Product Change Notice (PCN)

PCN Number: PCN-0450881R-01

Product(s) Affected: PJ1-022

| PREVIOUS CUI DEVICES DETAIL / IMAGE | | |

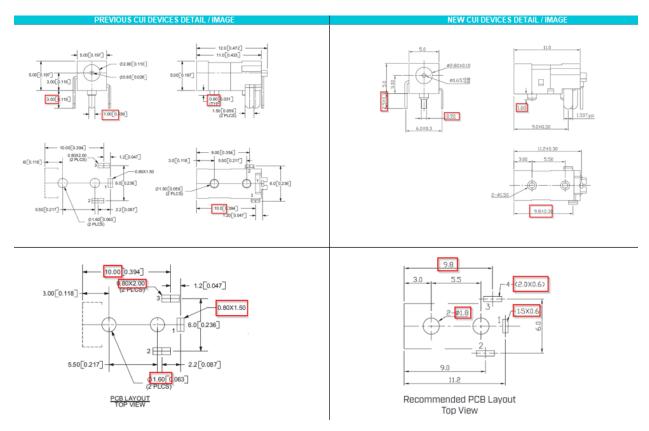
Description of Change: Minor Housing and footprint differences. Material Change on the

housing and terminals. See image Below

| PREVIOUS CUI DEVICES DETAIL / IMAGE | | |
|-------------------------------------|--------------|---------|
| | MATERIAL | PLATING |
| center pin | brass | silver |
| terminal 1 | brass | silver |
| terminal 2 | copper alloy | silver |
| terminal 3 | brass | silver |
| plastic | PA66 | |
